1997 - 1998 Corvette: Service Bulletin: Loose Lower Front Fascia Valance Panels

Number: 73-15-12A

REVISION: 07/14/98 DIVS INVL 1 7

SUBJECT: LOOSE LOWER FRONT FASCIA VALANCE PANELS (INSTALL ADDITIONAL ADDITIONAL WASHERS)

Figure 1

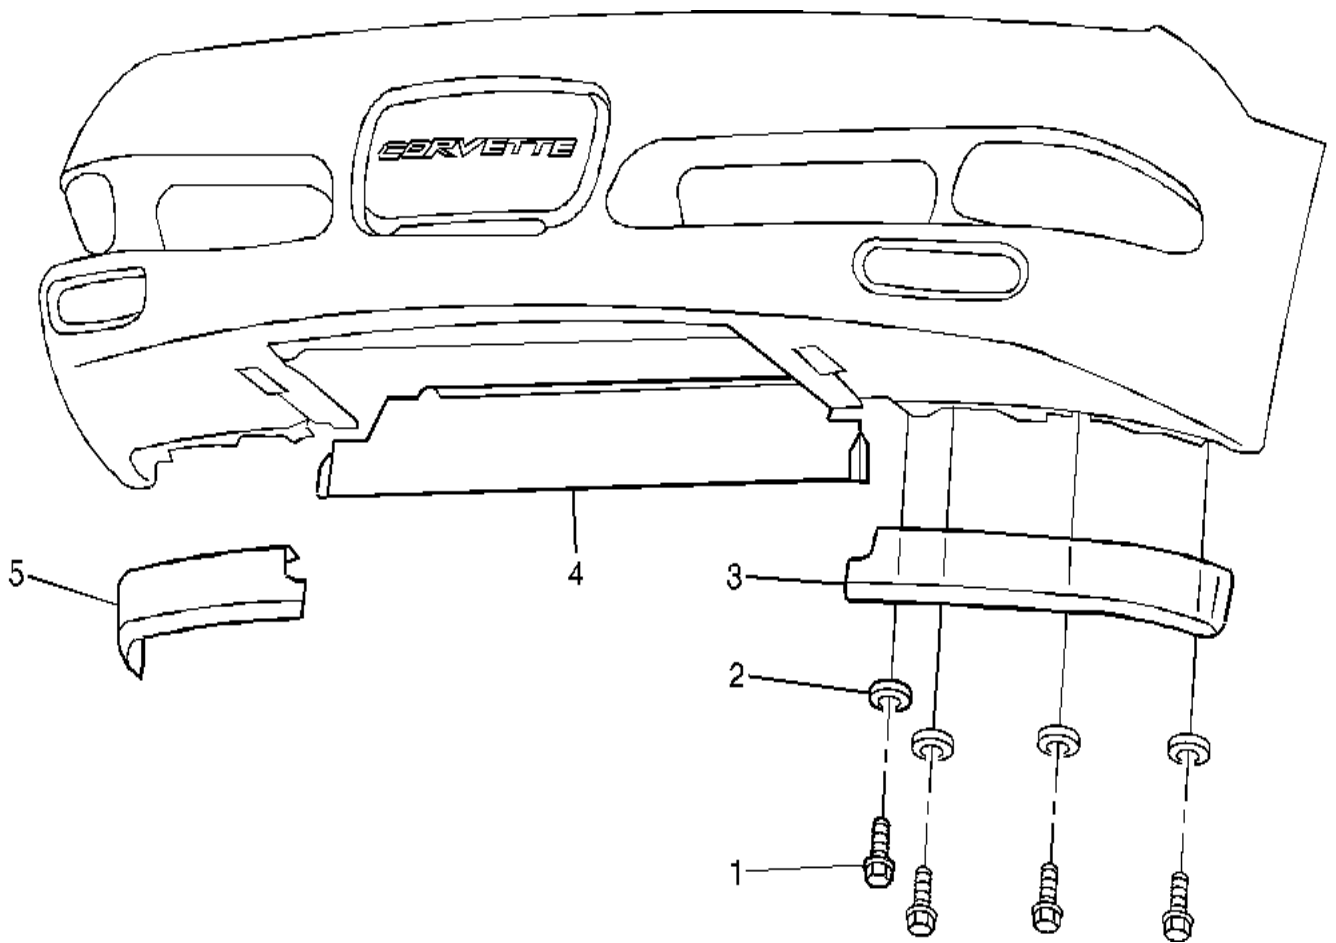
SOME OWNERS MAY COMMENT THAT THE LOWER FRONT FASCIA VALANCE PANELS APPEAR LOOSE.

THE ORIGINAL WASHERS ON THE BOLTS/SCREWS THAT ATTACH THE LOWER VALANCE PANELS TO THE FRONT FASCIA MAY HAVE WORKED THEIR WAY THROUGH THE HOLES IN THE VALANCE PANELS.

ADD ONE ADDITIONAL LARGER FLAT WASHER, P/N 11500365, 25 MM O.D. BY 6.3 MM I.D. BY 2.5 MM THICK (1 IN. O.D. BY 1/4 IN. I.D. BY 3/32 IN. THICK) TO EACH OF THE EIGHT BOLTS/SCREWS (FOUR PER VALANCE PANEL) THAT ATTACH BOTH LOWER VALANCE PANELS TO THE FRONT FASCIA (SEE FIGURE 1). TIGHTEN BOLTS TO 7 N.M (62 LB IN).

VEHICLES BUILT AFTER THE ABOVE LISTED VIN BREAKPOINTS HAVE VALANCE PANELS WITH A SMALLER HOLE DIAMETER AND NEW FASTENERS. AS A RESULT, IT IS NOT NECESSARY TO INSTALL ADDITIONAL WASHERS ON THESE VEHICLES.
